Access Compliance Report

Public Rights-of-Way

Intersection ID: 42947	Main Street: MOONDANCE_LN	Cross Street: SEBASTIANI_DR	Location: SW
ADA ID: BE045926A722	Ramp Type: PerpDiag	Initial Pass/Fail: Fail	Overall Compliance: No
		Severity Score: 10

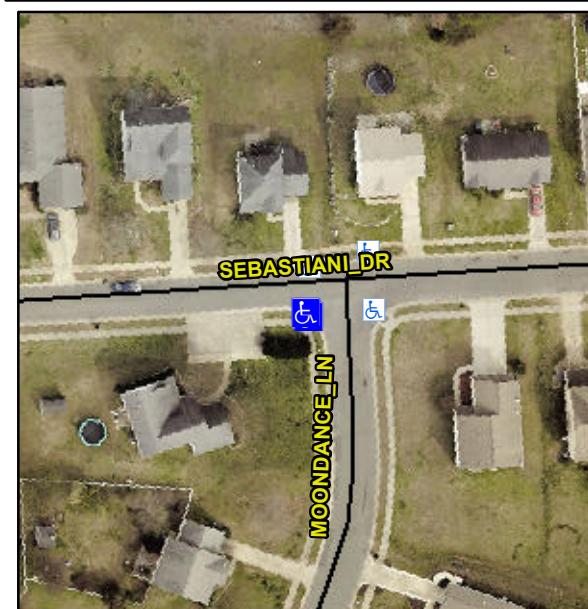
Not Found, R304.5.1, R304.5.3

Compliance	Description	Data	Compliance	Description	Data
N/A	Ramp Length (in)	48.0	Yes	Ramp Slope (%)	6.2
No	Ramp Width (in)	43.0	No	Ramp XSlope (%)	3.2
N/A	Flare Type LT	N/A	N/A	Flare Type RT	N/A
N/A	Flare Slope LT (%)	N/A	N/A	Flare Slope RT (%)	N/A
N/A	Flare Traversable LT?	N/A	N/A	Flare Traversable RT?	N/A
N/A	Landing Length (in)	N/A	N/A	DWS Provided?	N/A
N/A	Landing Width (in)	N/A	N/A	DWS Contrast?	N/A
N/A	Landing Slope (%)	N/A	N/A	DWS Length (in)	N/A
N/A	Landing X Slope (%)	N/A	N/A	DWS Full Width?	N/A
N/A	Landing Curb? (Y/N)	N/A	N/A	DWS Offset (in)	N/A
N/A	Shared Landing?	N/A			
N/A	Gutter Ponding?	N/A	N/A	Gutter Slope (%)	N/A
N/A	Gutter Lip Ht (in)	N/A	N/A	Gutter X Slope (%)	N/A
N/A	Painted X Walk1?	No	N/A	Painted X Walk2?	No
	X Walk 1 Direction	To E		X Walk 2 Direction	To N
N/A	X Walk 1 Width (in)	N/A	N/A	X Walk 2 Width (in)	N/A
	X Walk 1 Slope (%)	4.6		X Walk 2 Slope (%)	3.9
	X Walk 1 X Slope (%)	3.7		X Walk 2 X Slope (%)	1.3

Remove & Replace Curb Ramp With Two New Directional Ramps or Equivalent.
